Economic Commission for Europe**Inland Transport Committee****World Forum for Harmonization of Vehicle Regulations****Working Party on Passive Safety****Seventy-second session**

UN Global Technical Regulation No. 13 (Hydrogen and Fuel Cell Vehicles)**Proposal for Amendment 1 to UN Global Technical Regulation No. 13, Phase 2 (Hydrogen and Fuel Cell Vehicles)****Submitted by the informal working group on hydrogen and fuel cell vehicles, UN Global Technical Regulation No. 13, Phase 2 (Hydrogen and fuel cell vehicles) ***

The text reproduced below was prepared by the experts of the Informal Working Group (IWG) on hydrogen and fuel cell vehicles (HFCV), UN Global Technical Regulation No. 13, Phase 2 (GTR13-PH2) and proposes to enhance the global harmonization of the technical requirements of compressed hydrogen storage systems and of vehicles equipped with them. This document is based on informal document GRSP-71-09, distributed at the seventy-first session of the Working Party on Passive Safety (GRSP) with the incorporation of further amendments that reflect the feedback received on that informal document. The modifications to the existing text of the UN Global Technical Regulation N

Figure 53
Typical Compressed Hydrogen Storage System

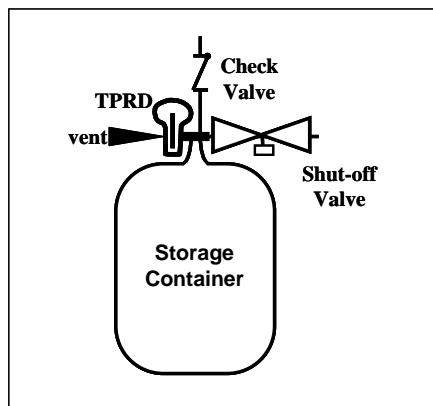
2147. Components of a typical compressed hydrogen storage system are shown in Figure 5-3. The system includes the container and all other components that form the "primary pressure boundary" that prevents hydrogen from escaping the system. In this case, the following components are part of the compressed hydrogen storage system:

Relationship between the initial burst pressure and end-of-life burst pressure (estimated)

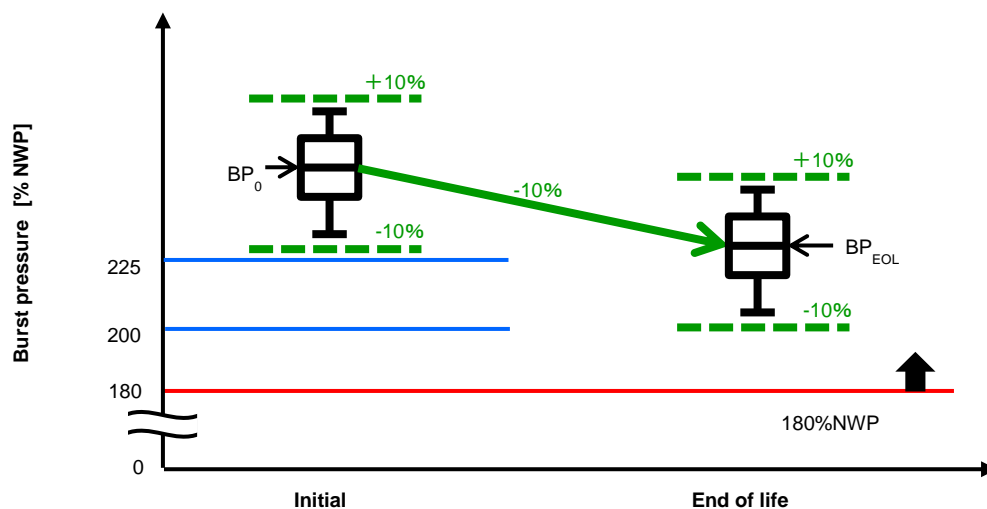
65. In subsequent discussions of Phase 2, Japan presented data from experiments using carbon-fibre composite containers for 70 MPa, to support the minimum initial burst pressure change from 225 per cent NWP to 200 per cent NWP for carbon fibre containers only (Tomioka, J. et al. (2019 September); "Influences of Hydraulic Sequential Tests on the Burst Strength of Type-4 Compressed Hydrogen Containers." 2019 International Conference on Hydrogen Safety. Technical Paper ID 159).

66. The relationship between the current initial burst pressure requirement and the estimated end-of-life burst pressure requirement is shown in Figure 6. The Japanese experiment showed that containers which met the $BP_0 \pm 10$ per cent requirement and

69. The results show that the minimum initial burst pressure of 225 per cent NWP can be reduced to 200 per cent NWP while maintaining end-of-life burst pressure (BP_{EOL}) above 180 per cent NWP and 80 per cent of BP₀ requirements.

Figure 7
Results from the Verification Test

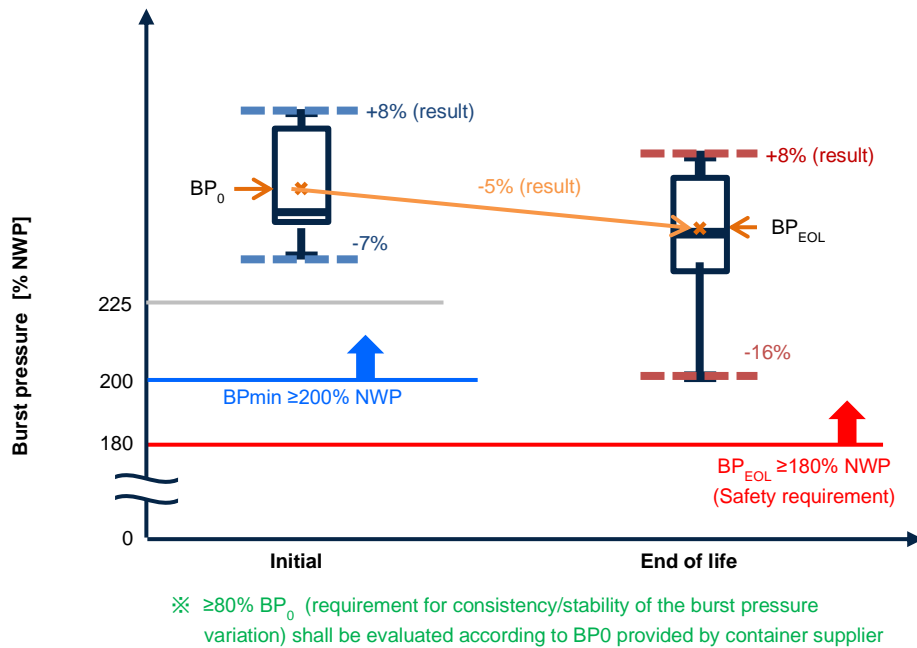
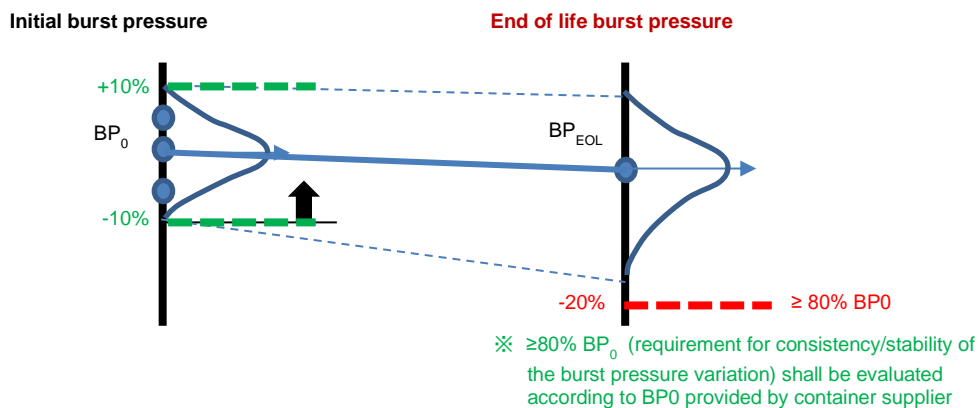
68. The test results are shown in Figure 7. The minimum value of the initial burst pressure was greater than 225 per cent, and within the ± 10 per cent of BP₀ requirement. The end-of-life burst pressure, which takes into account the variation and degradation ratio due to testing, was greater than 180 per cent NWP. It was also greater than 80 per cent of BP₀ by a sufficient margin (Figure 8).

Figure 11
Cylinder Temperatures during the Localized Fire Stage of Vehicle Fire Tests

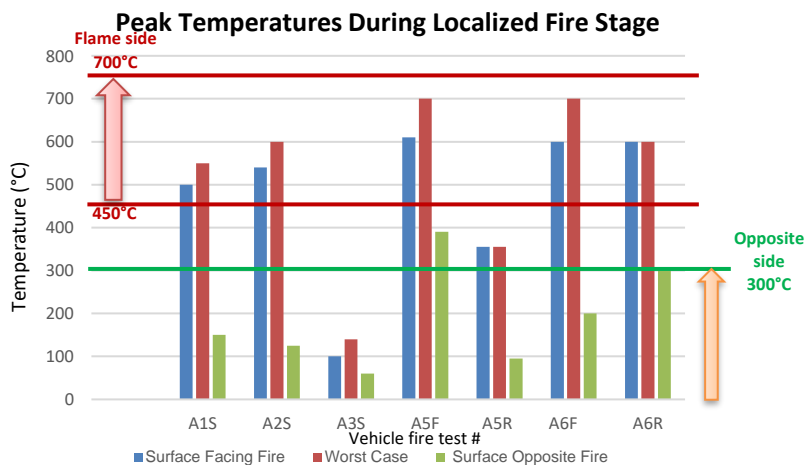
- (c) ~~The average of the maximum temperature during the localized fire period was less than 570°C with peak temperatures reaching approximately between 600 °C and 880 °C in some cases; As shown in Figure 11, peak temperatures on the surface of cylinders used for the vehicle fire test reached 700 °C during the localized fire stage. While this temperature is not as high as temperature levels experienced later during engulfing fire stage of the vehicle fire, they are adequate to cause serious material degradation while also challenging the ability of TPRDs to activate and vent the contents of the container;~~

8967. Based upon the above findings, performance-based limits as shown in Figures 11 and 12; the limits were defined to characterize the thermal exposure during the localized and engulfing fire stages. The maximum cylinder surface temperature during the localized fire stage for the side of the cylinder facing the fire was set to 50 °C above the highest value that was experienced during the JARI vehicle fire tests to provide a margin for testing. A maximum limit for the engulfing stage was not necessary as the temperature is a naturally limited flame temperature. The minimum surface temperatures on the side facing the flame were set to the lowest value in the range of data during the engulfing fire stage but was limited to one standard below average during the localized fire stage so that a challenging (but reasonable) thermal condition even though the full range of data was significantly skewed. The temperature profile in para. 6.2.5. was adopted. The selection of 600 °C as the minimum temperature for the localized fire hold period ensures that the average temperature and time of localized fire test exposure are consistent with test data. Thermocouples located 25 mm ± 10mm from the outside surface of the test article are used to control the heat input and confirm that the required temperature profile is met. In order to improve the response and controllability of the fire during testing (as well as reproducibility of results), the use of Liquefied Petroleum Gas (LPG) and wind guards are specified. Experience indicates the controllability of the LPG fire will be approximately ±100°C in outdoor situations, producing peak temperatures that also agree favourably with test results.

Figure 12
Cylinder temperatures during engulfing fire stage of vehicle fire tests

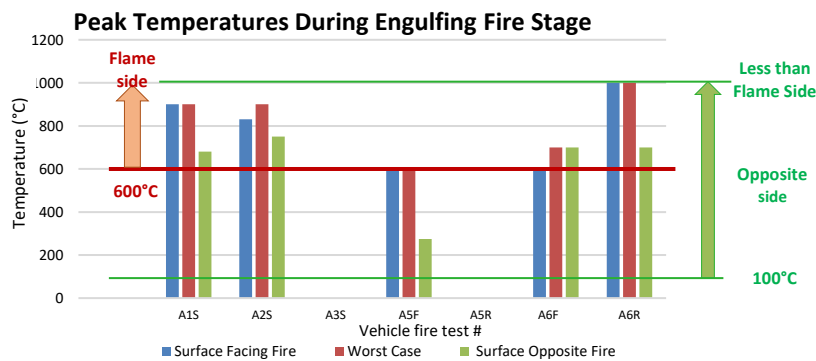
- (d) The rise in peak temperature near the end of the localized fire period often signaled the transition to an engulfing fire condition;-
- (e) As shown in Figure 12, the peak temperatures on the surface of cylinders used for the vehicle fire test reached 1,000 °C during the engulfing fire stage;

Figure 711
Temperature profile of fire test

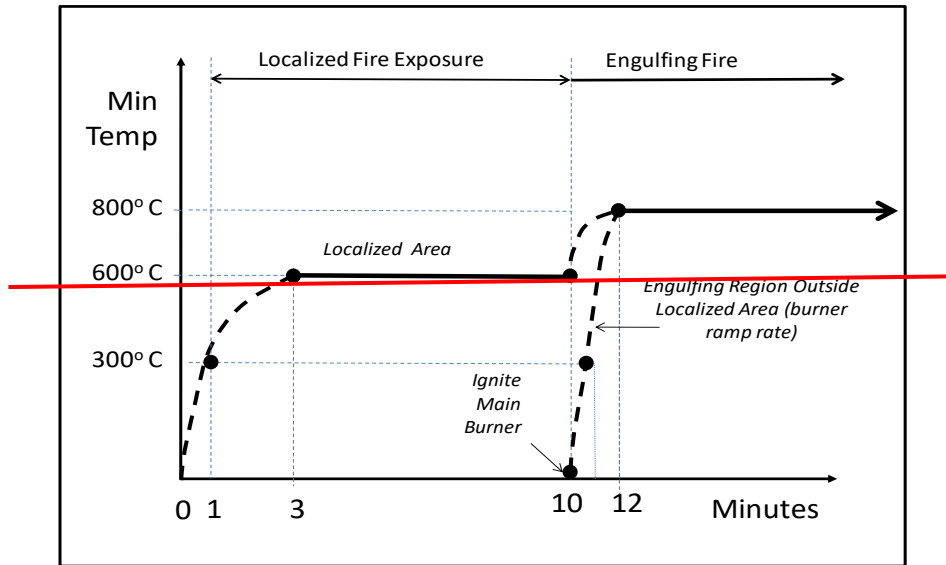
- ~~(f) As shown in Figure 7 the temperature of the thermocouples in the localized fire area has increased continuously to at least 300 °C within 1 minute of ignition, to at least 600 °C within 3 minutes of ignition, and a temperature of at least 600 °C is maintained for the next 7 minutes. The temperature in the localized fire area shall not exceed 900 °C during this period. Compliance to the thermal requirements begins 1~~

- (a) After ignition is confirmed, the fuel flow is set to the value that matches the desired specific heat release rate (HRR/A) for the localized burner in paragraph 6.2.5.4.5.3., and the test time is set to 0 minutes.
- (b) As shown in Figure 6 in paragraph 6.2.5., the 10-second rolling average of the burner monitor in the localized fire zone ($T_{B_{LOC25}}$) shall be at least 300 °C within 1 minute of ignition and for the next 2 minutes.
